ZBC_DROID/BLORB_subboard_USB_LTE

TABLE OF CONTENTS

Quanta Computer Inc.	
PROJECT : BC_DRO D BLORB			
SUB: Change List			
Date: Monday, January 15, 2020	Sheet: 8	of	9

Quanta Computer Inc. PROJECT : BC_DRO D BLOBB	
Size	Document Number
SUB: Change List	
Date: Friday, January 17, 2020	Sheet 9 of 9

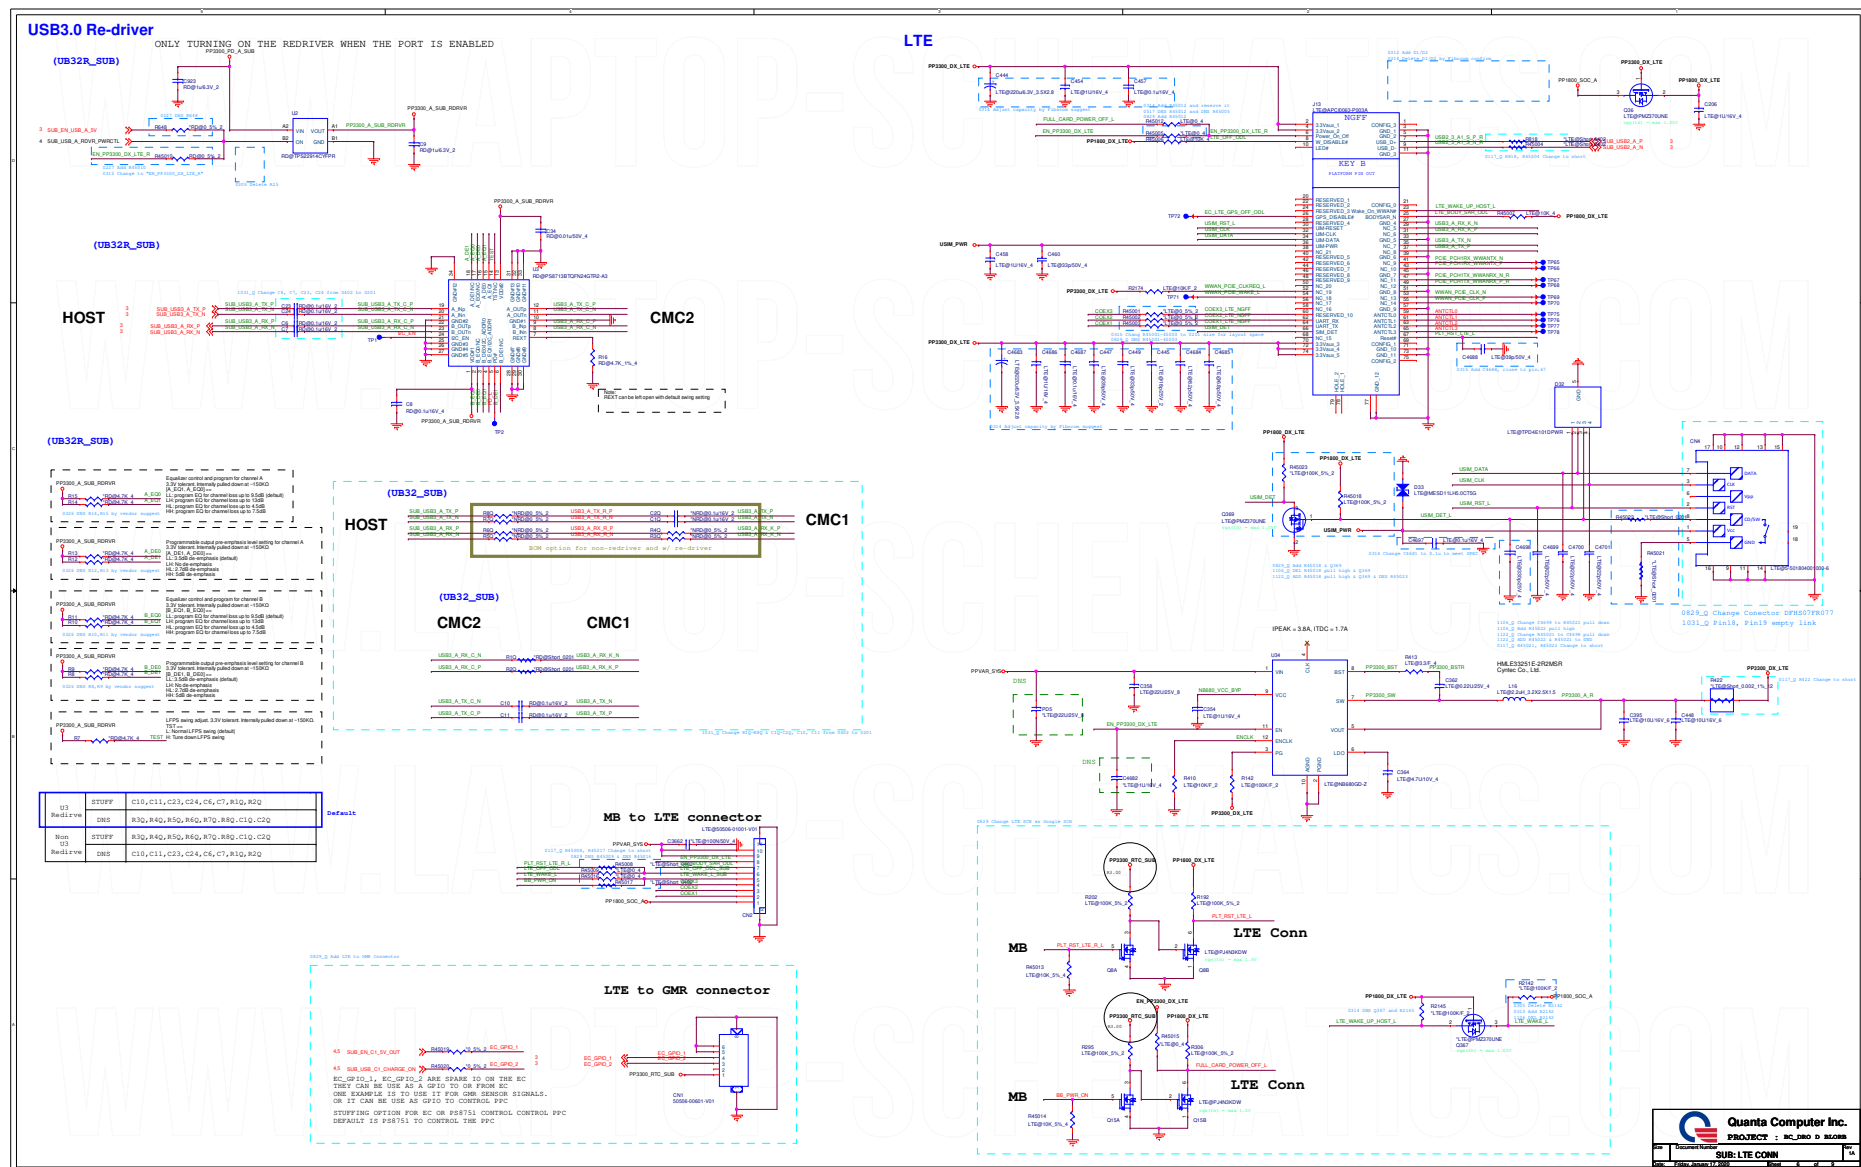
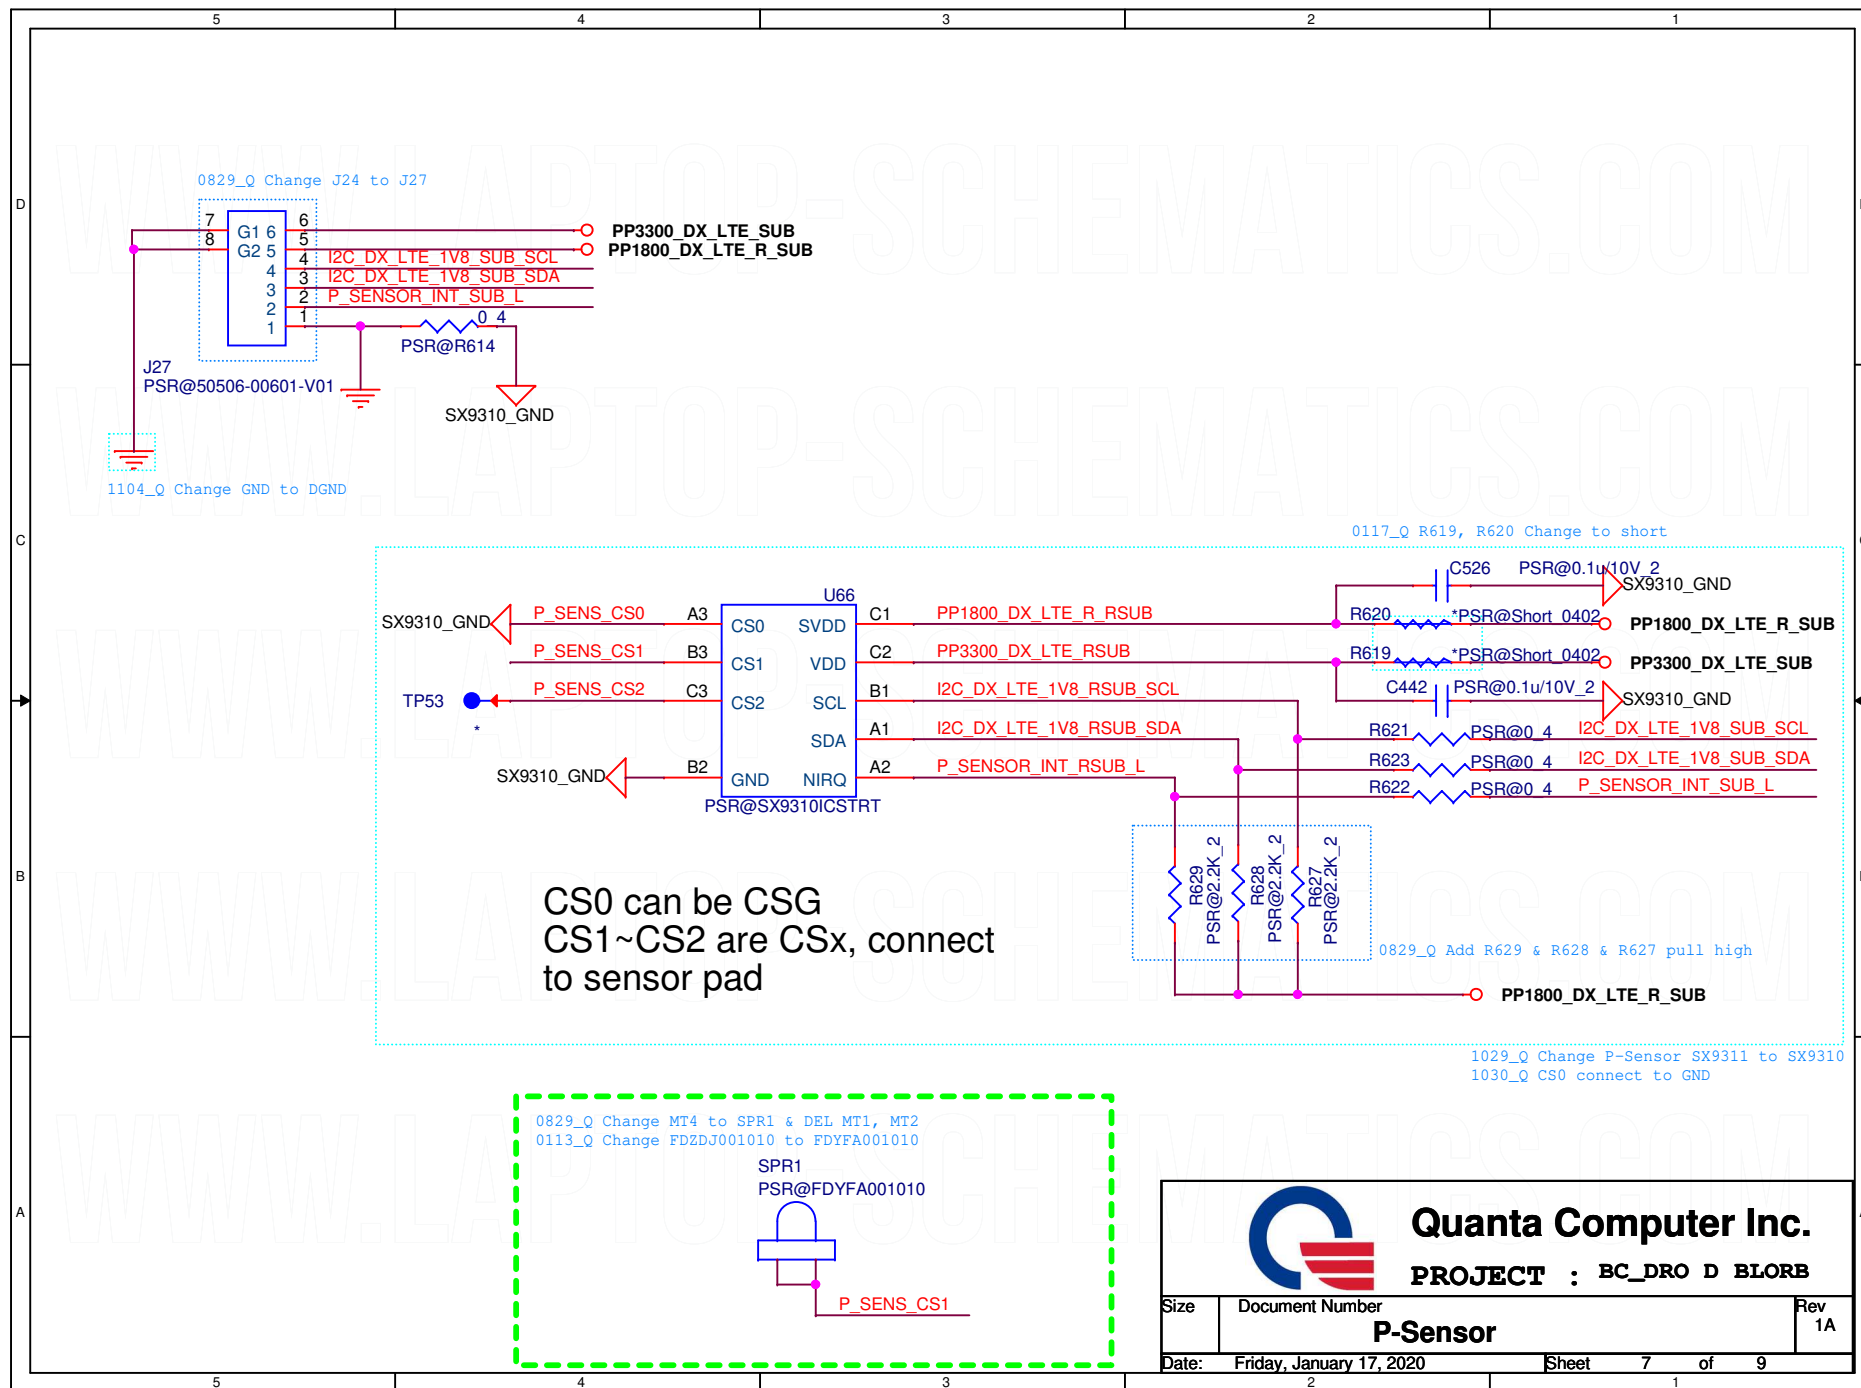
```
1031_Q DEL Hole1, Hole2, Hole3, Hole4, Hole5, Hole6
```

```
1030_Q Add Hole7, Hole8, Hole9, Hole10, Hole11, Hole12 , Hole13 & PAD1, PAD2, PAD3, PAD4, PAD5, PAD6
1031_Q Change PAD3 fp & PAD6 fp
```
